**MAJOR PROJECT ASSESSMENT:
Main Works for Barangaroo Headland
Park & Northern Cove
MP 10_0048**

Director-General's
Environmental Assessment Report
Section 75I of the
Environmental Planning and Assessment Act 1979

March 2011

Figure 17: Project site boundary and sensitive receivers

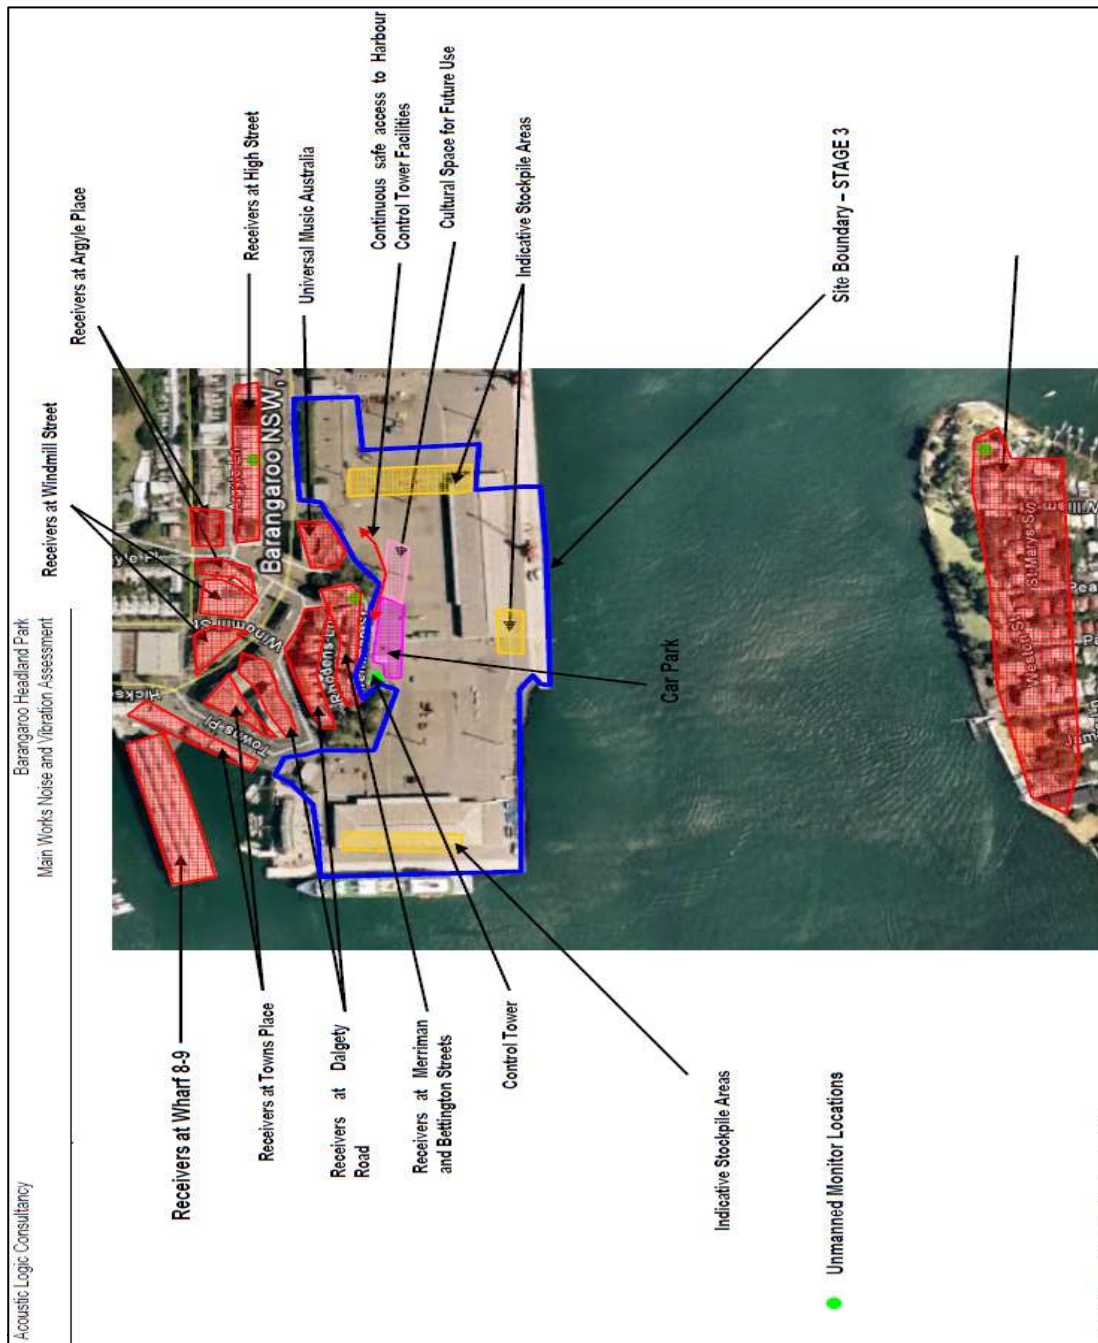
The proponent has submitted a preliminary Noise and Vibration Management Plan (NVMP) that will be used to manage identified impacts from the construction activities of the site. The NVMP outlines the development controls and safeguards that would be applied by the proponent, and provide guidance for the ongoing management of activities on the site. The objective of these controls is to ensure that all work is carried out in a highly controlled and predictable manner that will minimise emissions and protect the amenity of the sensitive receivers surrounding the site (refer to **Figure 17**).

The issues associated with vibration have been largely covered within the noise assessment above, as the specific receivers (refer to **Figure 17**) also measured potential vibration impacts. The most potential impacts from vibration are from receivers at the HCT, Moore's Wharf Facility, residential receivers on Merriman and Bettington Streets and the Universal Music commercial building.
